SERVICE BULLETIN

Ref. CE-013

Subject: MODIFICATION OF THE POWER CIRCUIT
 Model: 2000A

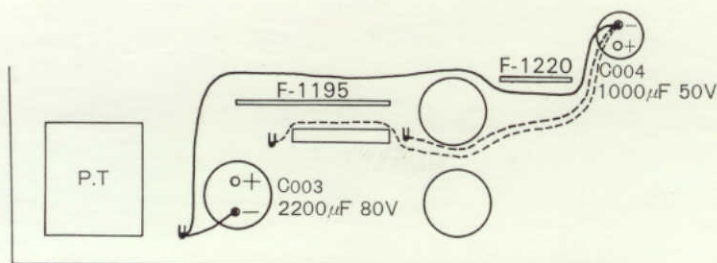
1. If noise (input shorted) is noticeable in the power amplifier sections, change the connecting wire and grounding point in the power circuit.
 See Fig. below:

2. If Hum level is noticeable on PHONO 1 or 2 of the SELECTOR, insert the ripple filter between the equalizer amplifier "F-1253 (+B) and power circuit" F-1195 (5).
 See Fig. below:
